AIA Document G701® – 2017

Change Order

PROJECT: *(Name and address)*
Mansfield ISD Wester Middle School
Early Abatement and Demolition
1520 North Walnut Creek Drive
Mansfield, Texas 76063

CHANGE ORDER INFORMATION:
Change Order Number: 001
Date: March 05, 2026

RFP No 1, Civil Item 1: To the Drawings, Sheet C7.05, "CAPITAL IMPROVEMENTS STRIPING PLAN,"

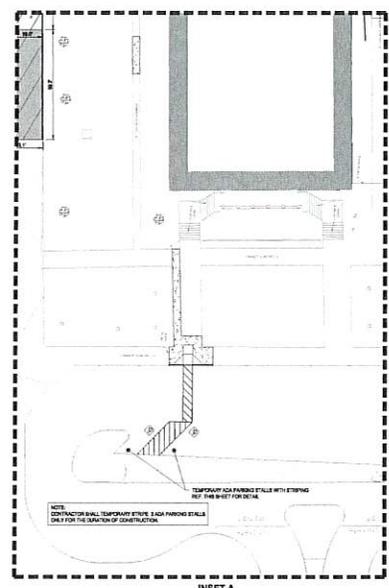
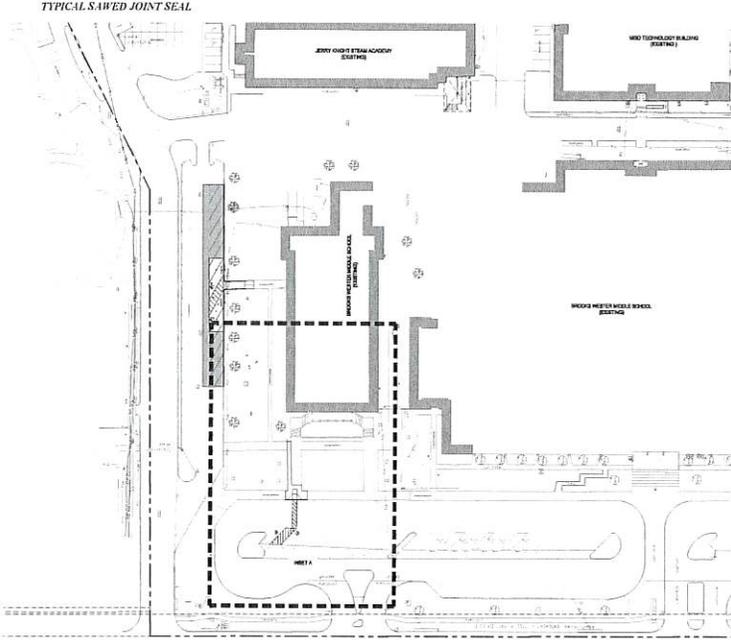
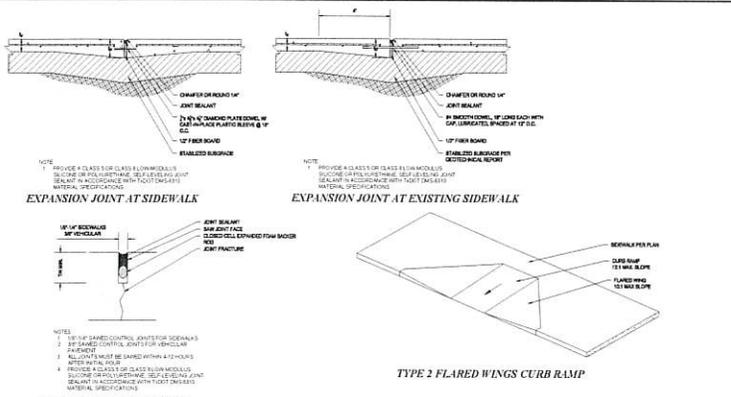
- 1) ADA sidewalk improvement with a type 2 flared wings curb ramp.
- 2) Paving striping provided for path to handicap parking.
- 3) Paving details added.

1 FLOOR PLAN - AREA B - PHASE 3A

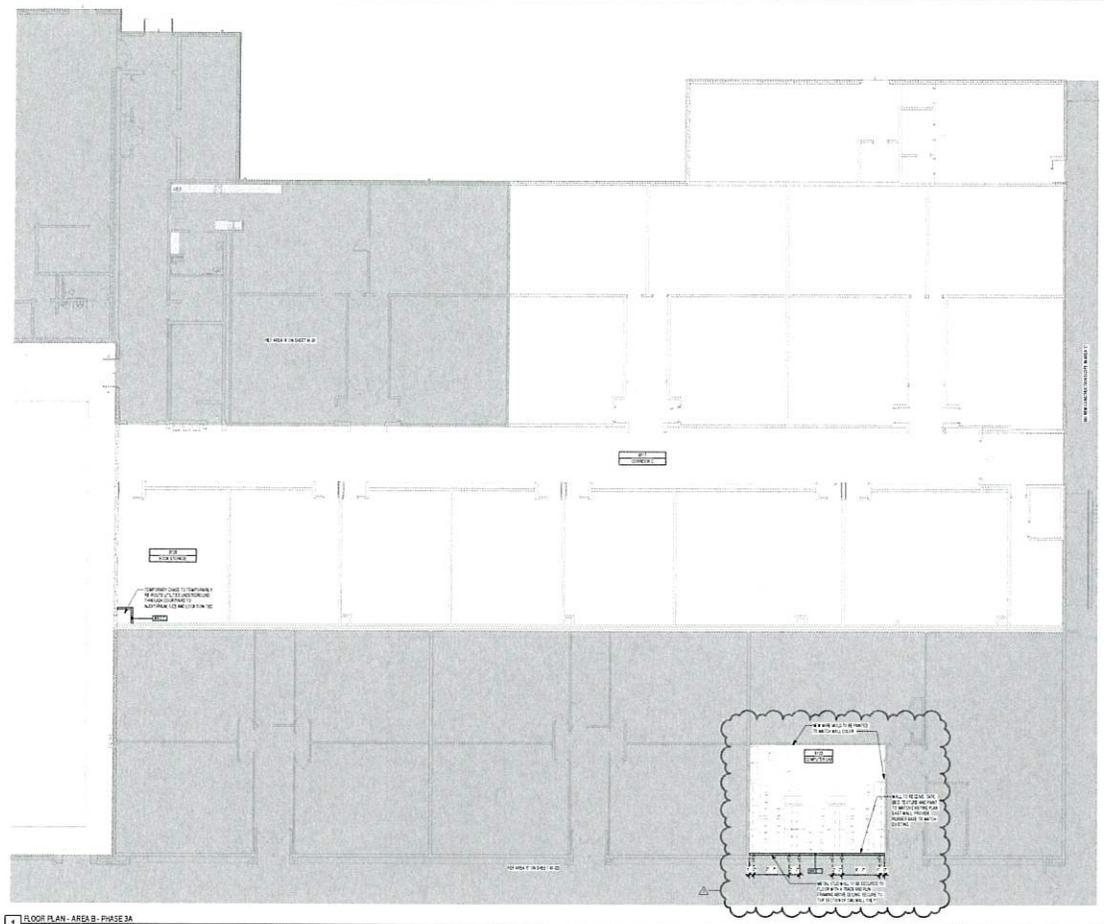
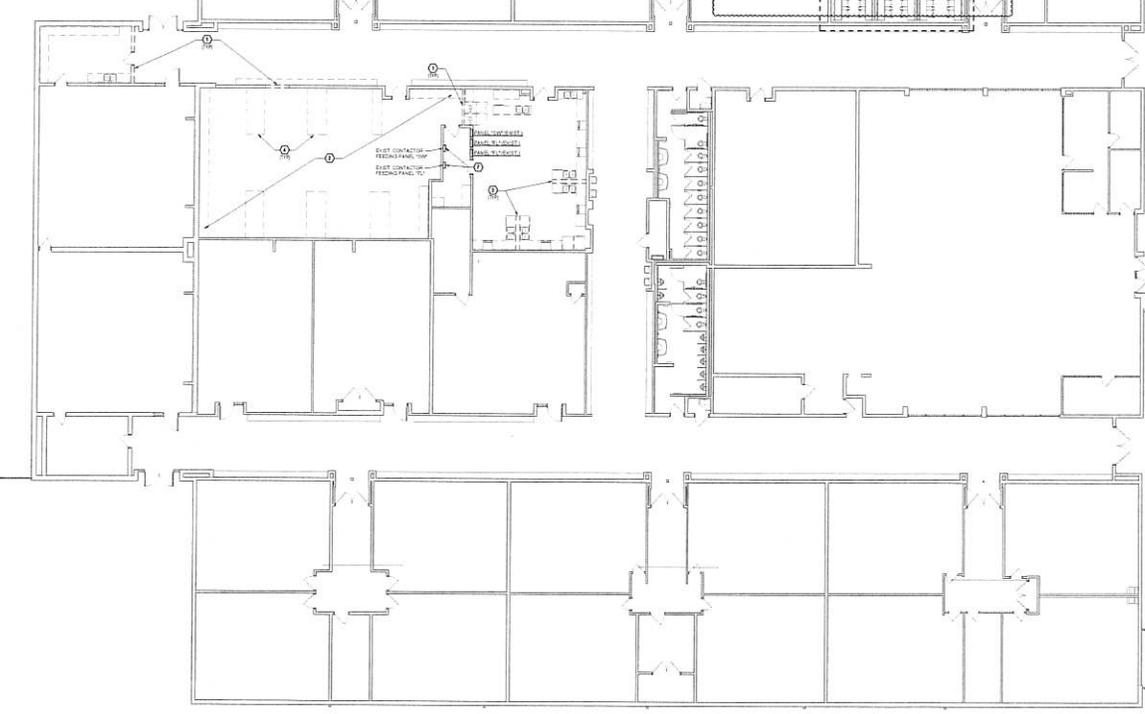
- 1) Metal stud, gyp furr out wall added to the plan south wall of the Computer Lab.

DEMOLITION PLAN - AREA E - ELECTRICAL
PACKAGE 3A
DATE: 08/11/11
DRAWN BY: [Name]
CHECKED BY: [Name]
SCALE: AS SHOWN
PROJECT NO: EQ-02

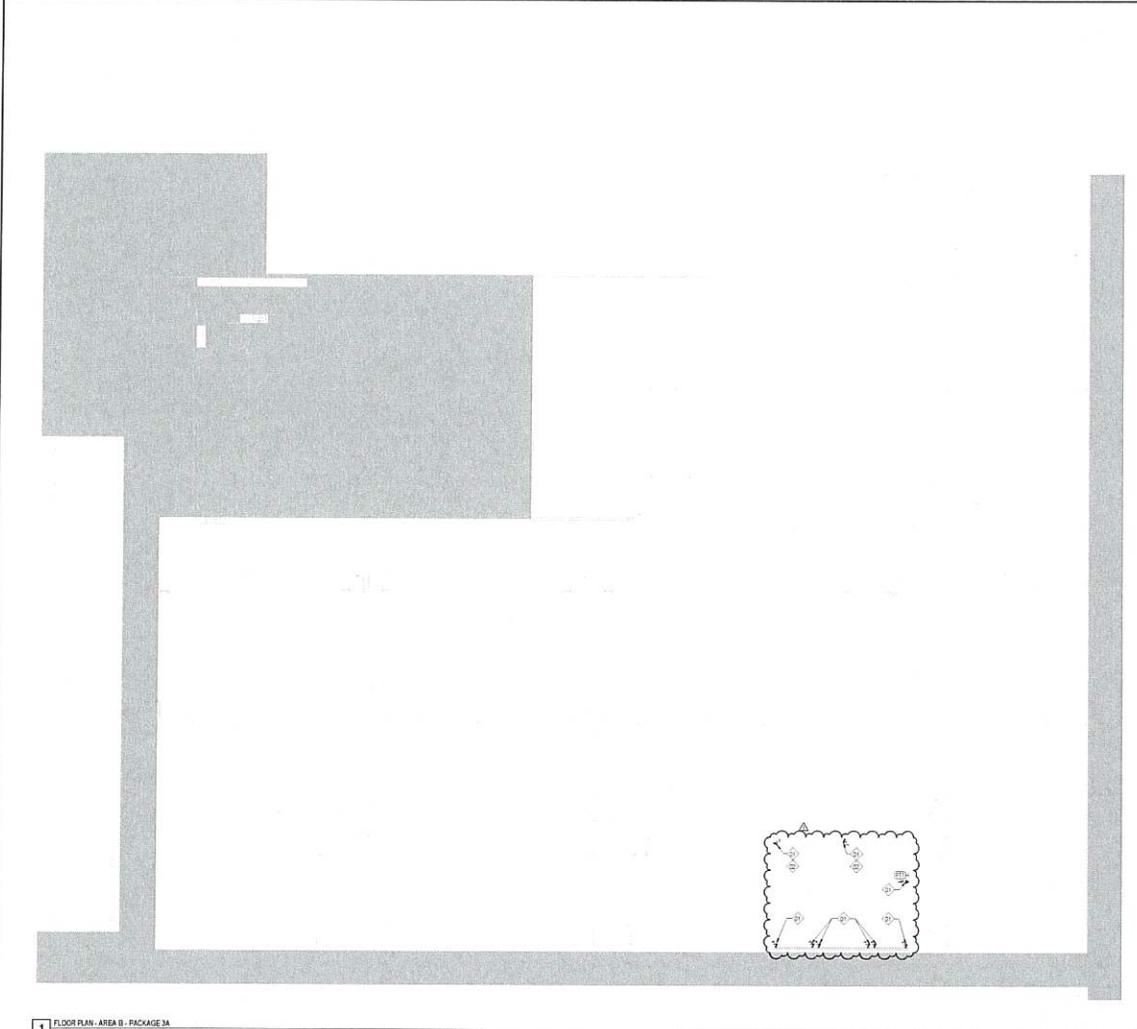
- 1) Refer to new partial plan and additional notes for revisions to accommodate new computer lab setup.
- 2) Refer to new detail for technology rough-in coordination.

1 SITE PLAN - PACKAGE 3A
T-462

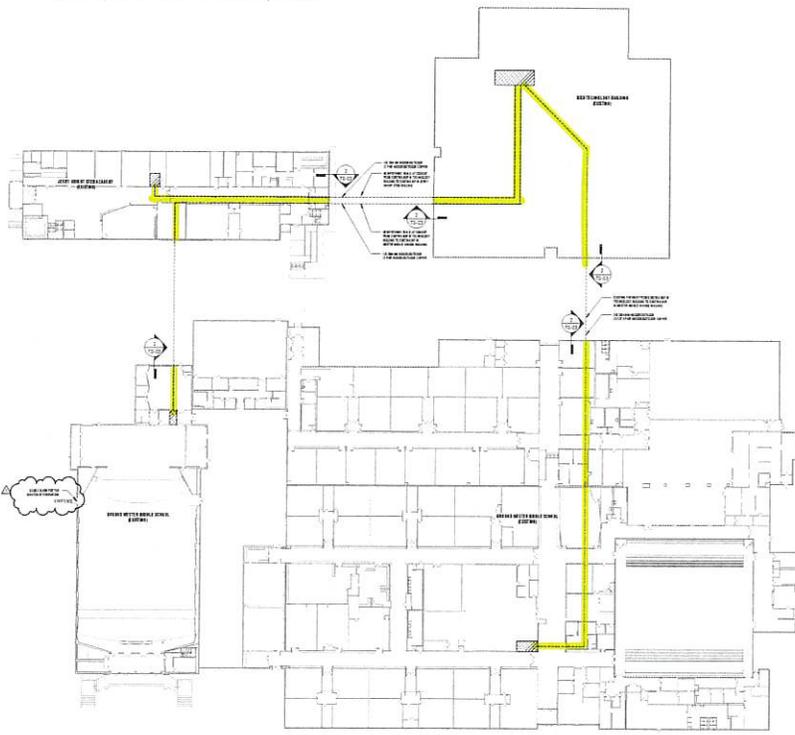
Please confirm if J-hooks are an acceptable mounting condition for the interior pathways of the fiber optic cable as shown on T0-03. Exterior runs will be installed in 4" conduit as shown.

Per GMP1 RFI #7, 4" conduit for the interior fiber cabling pathways is not required. J-hooks will be installed above the ceiling as shown on sheet T0-03. A credit for all materials and labor associated with the omitted conduit pathways is included.
